Condensation In Headlamps –
Revised Headlamp Cap Available –
Repair Procedure

MODEL 2002-04 MY
X-TYPE

VIN C00001-E06300

ILLUSTRATION 1

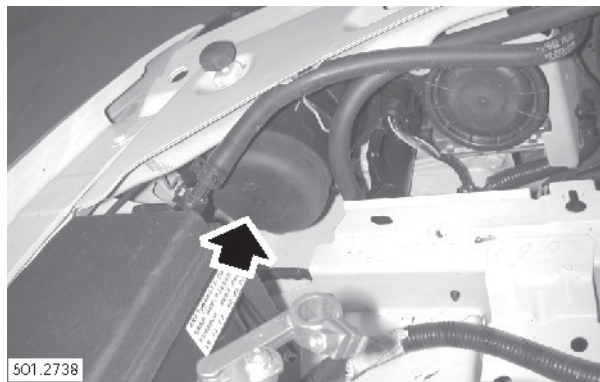
Some 2002-04 MY X-TYPE vehicles within the above VIN range, may exhibit condensation buildup within the headlamp assemblies. A revised cap for the low beam (outer) headlamp has been released to address this concern.

1. Remove battery (see Workshop Manual, section: 414-01, SRO 86.15.01).
2. Unclip the left-hand-side low beam (outer) headlamp cap and remove cap (Illustration 1, left-hand-side shown, right-hand-side similar).

In case of a customer concern of condensation buildup within the headlamp assemblies, install a revised low beam (outer) headlamp cap as described in the procedure below.

3. Install the new headlamp cap, reposition clips and secure cap.
4. Carry out step 2 and 3 for the right-hand-side headlamp cap.
5. Install battery (see Workshop Manual, section: 414-01, SRO 86.15.01).
